Administrative Hearing Agenda

September 17, 2026 at 10:00 a.m.

STAFF REPORT AND ACTION FORM

Subject: **RP001-27 Third Addition Gordon Subdivision** A request by Bennett Engineering, on behalf of John E. Karish and Marie A. Lee, to vacate the common interior lot lines between Lots 7, 8, and 9, Block G, Third Addition Gordon Subdivision, resulting in one lot of approximately 2.94 acres.

REPLAT LOTS 1, 2A AND 2B, PHIPPS SUBDIVISION

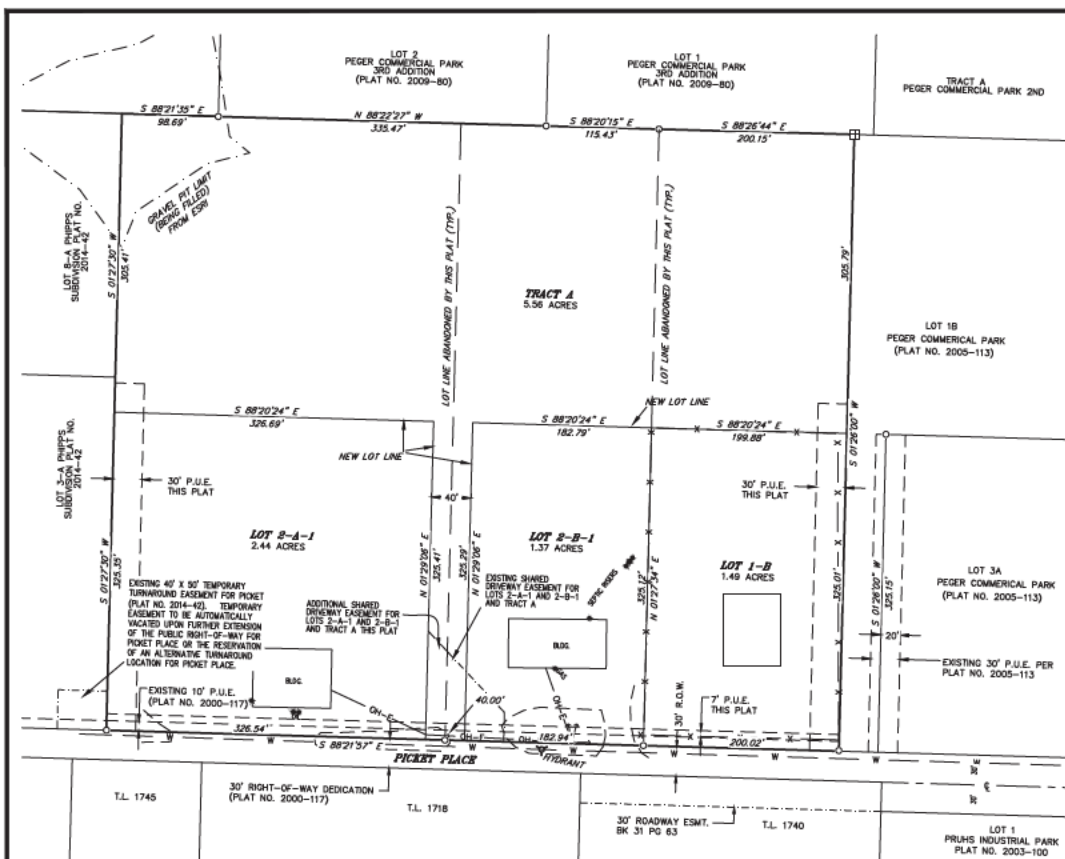
Vicinity Map: "University Avenue" should be "S University Avenue".

RP002-27 is located in the "X" flood zone. Development occurring in this flood zone is not required to meet FNSBC 15.04 Floodplain Management Regulations. Note #6 is accurate.
